LOUISIANA
POWER & LIGHT

April 7, 1988

SUBJECT: **Waterford 3 SES**
Docket No. 50-382
Updated QA Program

REF: 001
 FIG. 17.2-2
 PG. 17.2-62

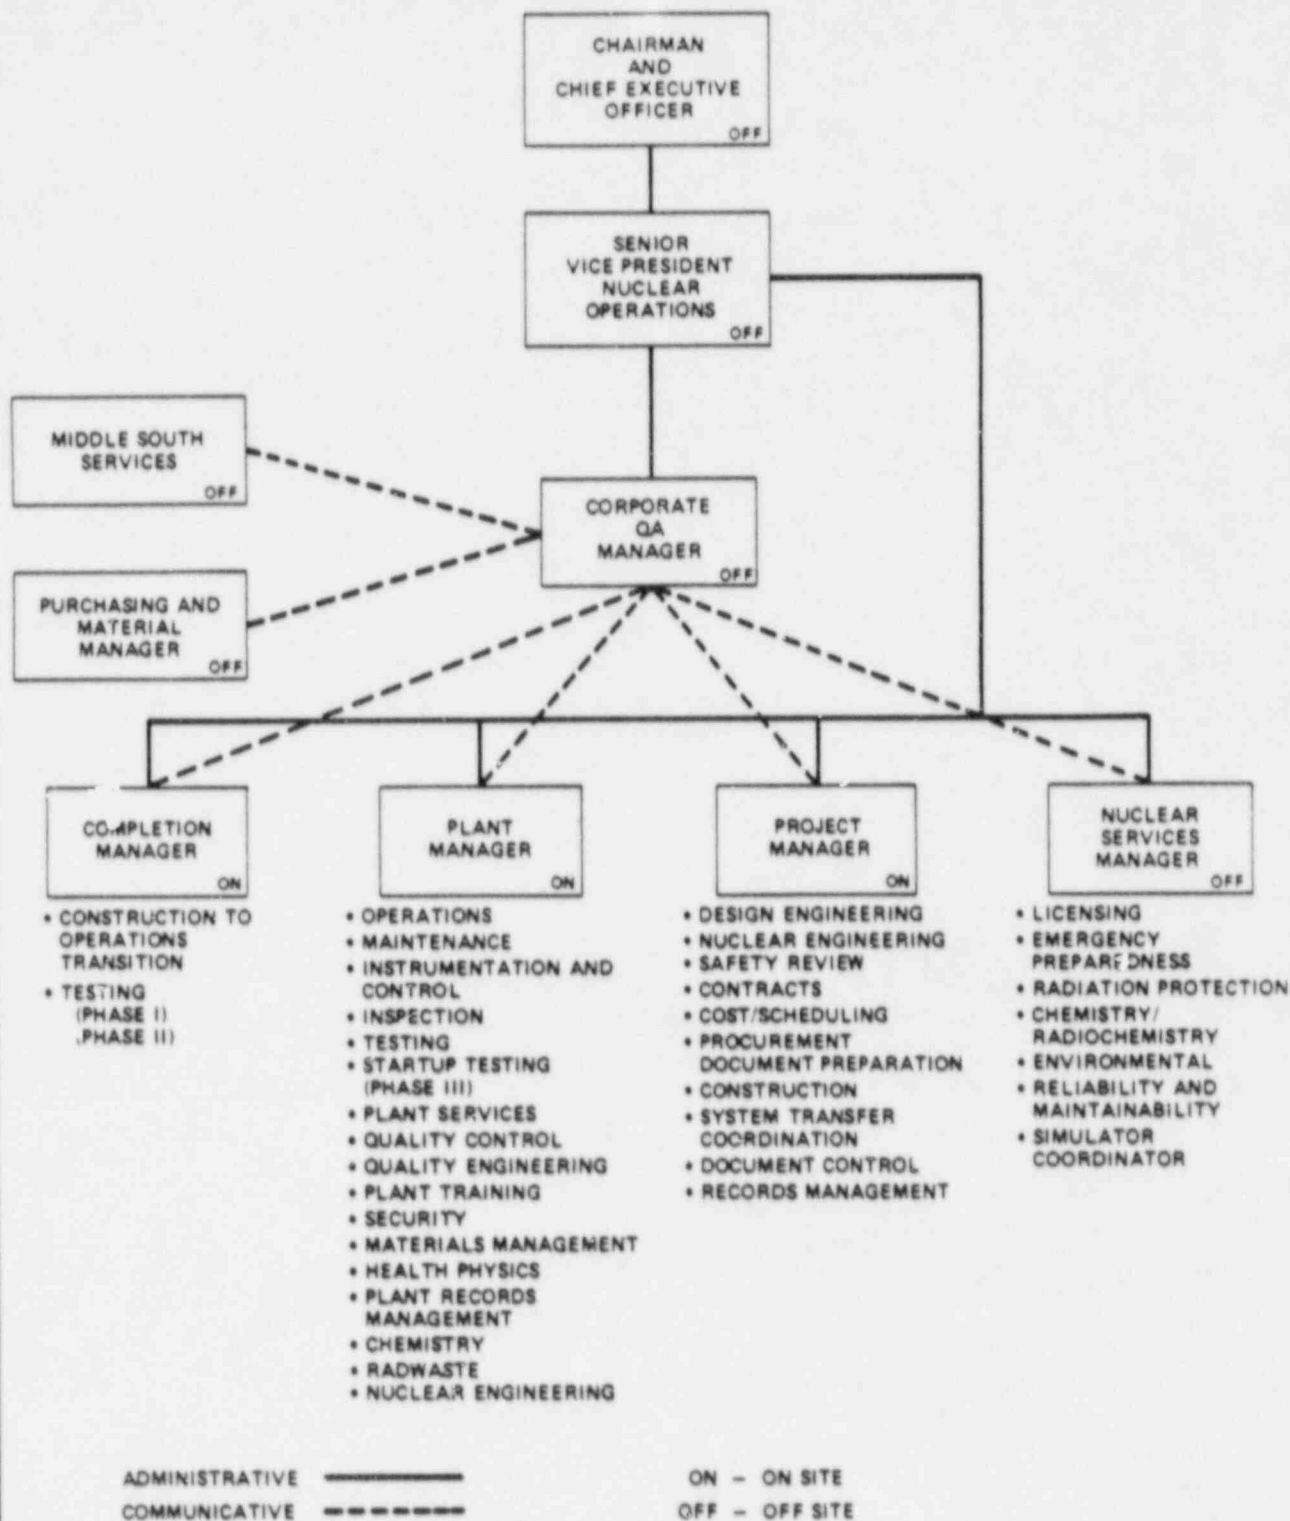
COMMENT	DESCRIPTION
001	This revision incorporates the deletion of references to construction and start-up testing and reflects the reorganization of the Nuclear Operations Department.
002	The Corporate level quality policies presently contained in Section V and VI of the Nuclear Operations Management Manual (NOMM) have replaced the Nuclear Operations Department Quality Assurance Manual. Sections V and VI of the NOMM define the Nuclear Operations Department Quality Assurance Program. The accessibility to the QA program description has been enhanced by the inclusion into the NOMM. Additionally, all Nuclear Operations Sr. Management are responsible to concur/approve the NOMM thereby assuring their ongoing cognizance of the QA Program.
003	The term "safety related" has replaced "quality related" throughout this revision, however the scope of the activities remains unchanged. The current usage of the term "safety related" in 17.2.2.4 is more consistent with LP&L QA Program documentation and provides LP&L management the option of applying 10CFR50, Appendix B criteria to "non-safety related" activities by categorizing the activity as "quality related". The Nuclear Operations Management Manual provides the definitions and scope of quality and safety related as they relate to the LP&L Nuclear Quality Program.
